Wisconsin Department of Transportation

**Proposal #16: 1517-75-83, WISC 2017 272
 USH 10 – USH 10/STH 441
 County CB – Oneida St
 Oneida St (Valley Rd & Midway Rd)
 USH 10
 Winnebago County**

This is Addendum No. 01, which provides for the following:

ADDENDUM NO. 01

Addendum No. 01
ID 1517-75-83
Revised Sheet 20
April 27, 2017

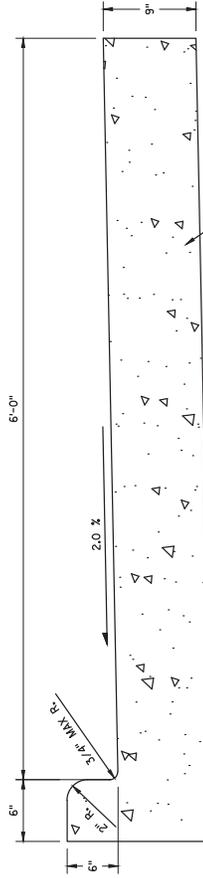
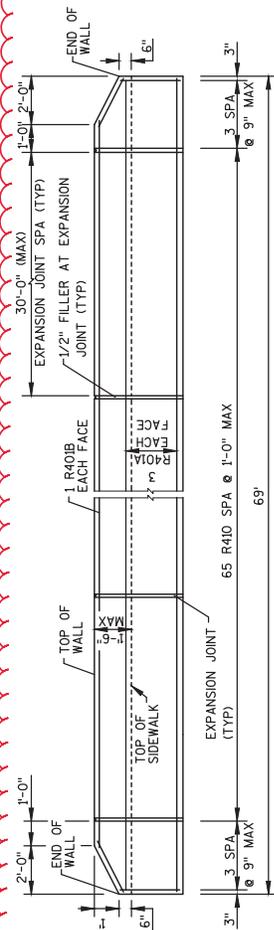
Revised Plan Sheets	
Plan Sheet	Plan Sheet Title (brief description of changes to sheet)
20	Concrete Curb & Gutter 78-Inch Type A, Special Detail (Updated to show that it is doweled)
26	Concrete Grade Beam Detail (Updated to show Bill of Bars information)
27	Concrete Grade Beam Detail (Updated to show Bill of Bars information)
28	Concrete Grade Beam Detail (Updated to show Bill of Bars information)
149	Miscellaneous Quantities (Updated with HMA Cold Weather Paving Item)
